FARR WEST CITY PLANNING COMMISSION AGENDA

RE: **PETERSEN BLAST BOOTH SITE**
Site Plan Review

Our office has completed a review of the site plan for the Petersen SF Blast Booth on the Petersen Inc. property located at 1461 North 2000 West. This new Blast Booth Structure will replace the existing concrete piers/foundations in this area and will include new asphalt and concrete surfacing in addition to the structure. The proposed asphalt will drain off into the existing site. The only utilities being installed to the site include natural gas, power, and compressed air. We recommend approval of this plan subject to the following comments:

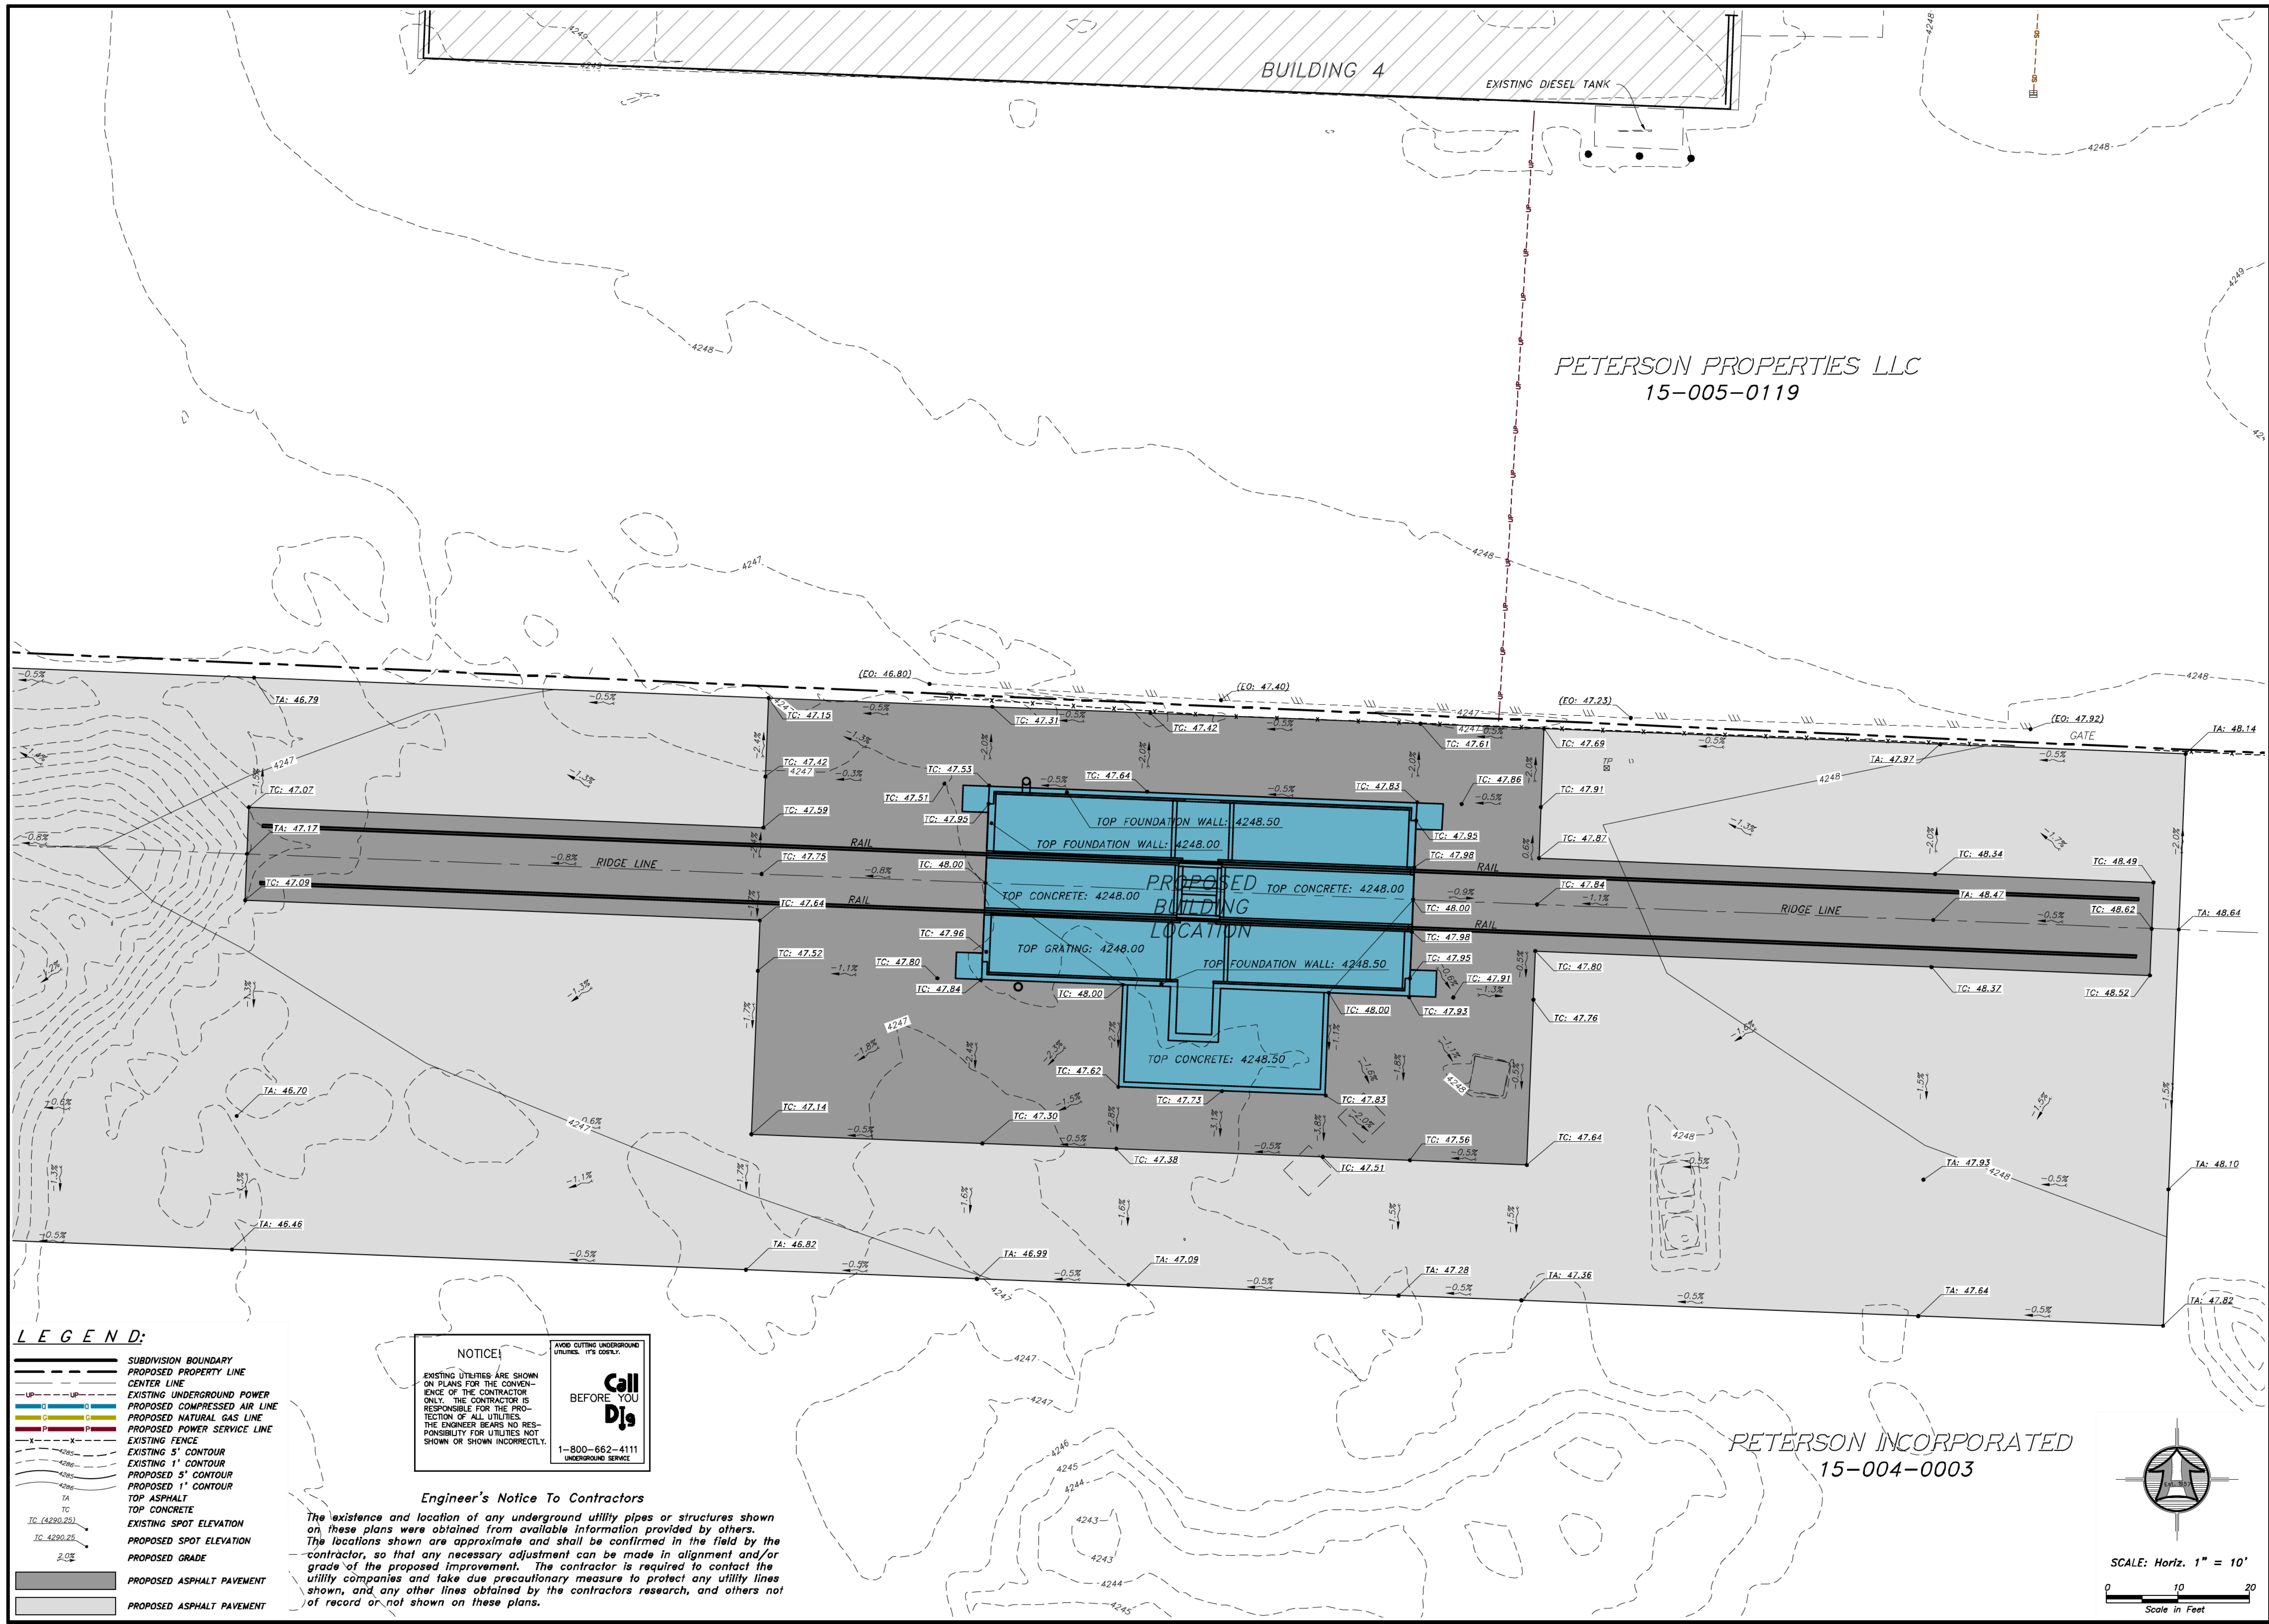
1. It appears that there have been buildings and other site development that have been completed in the last 5-6 years on this parcel and the parcel to the south that did not go through the site plan review process with the City. Please provide an overall site plan showing these changes and demonstrate how the storm drain runoff in this area is being handled so that we can verify that the City's storm drain standards are being met.
